Access Compliance Report

Public Rights-of-Way

(Curb Ramps)

Intersection ID: 10709	Main Street: MORSON_ST	Cross Street: PRYOR_ST	Location: NW
ADA ID: AC52E97CC4D8	Ramp Type: PerpDiag	Initial Pass/Fail: Fail	Overall Compliance: No
Severity Score: 13.75			
Codes/Mitigation Info/Possible Solution		Field Measurements/Component Compliance

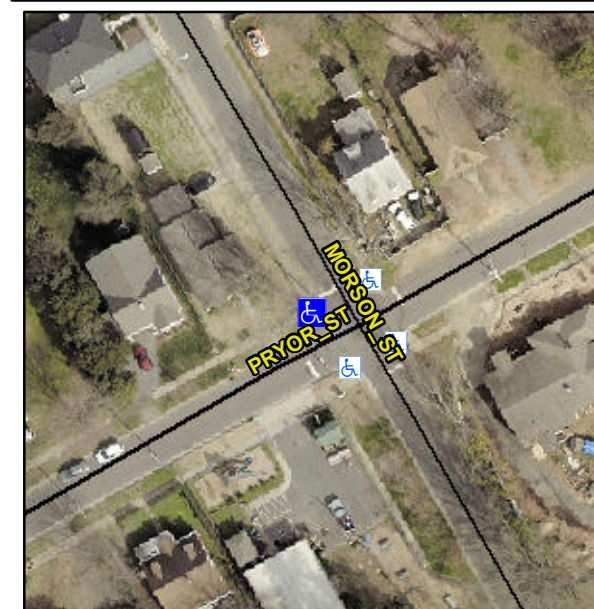
Not Found, R304.2.2, R304.5.3

Compliance	Description	Data	Compliance	Description	Data
N/A	Ramp Length (in)	68.0	No	Ramp Slope (%)	9.2
Yes	Ramp Width (in)	48.0	No	Ramp XSlope (%)	2.6
N/A	Flare Type LT	N/A	N/A	Flare Type RT	N/A
N/A	Flare Slope LT (%)	N/A	N/A	Flare Slope RT (%)	N/A
N/A	Flare Traversable LT?	N/A	N/A	Flare Traversable RT?	N/A
N/A	Landing Length (in)	N/A	N/A	DWS Provided?	N/A
N/A	Landing Width (in)	N/A	N/A	DWS Contrast?	N/A
N/A	Landing Slope (%)	N/A	N/A	DWS Length (in)	N/A
N/A	Landing X Slope (%)	N/A	N/A	DWS Full Width?	N/A
N/A	Landing Curb? (Y/N)	N/A	N/A	DWS Offset (in)	N/A
N/A	Shared Landing?	N/A			
N/A	Gutter Ponding?	N/A	N/A	Gutter Slope (%)	N/A
N/A	Gutter Lip Ht (in)	N/A	N/A	Gutter X Slope (%)	N/A
N/A	Painted X Walk1?	No	N/A	Painted X Walk2?	No
	X Walk 1 Direction	To S		X Walk 2 Direction	To E
N/A	X Walk 1 Width (in)	N/A	N/A	X Walk 2 Width (in)	N/A
	X Walk 1 Slope (%)	0.1		X Walk 2 Slope (%)	5.1
	X Walk 1 X Slope (%)	3.3		X Walk 2 X Slope (%)	0.2

Remove & Replace Curb Ramp With Two New Directional Ramps or Equivalent.
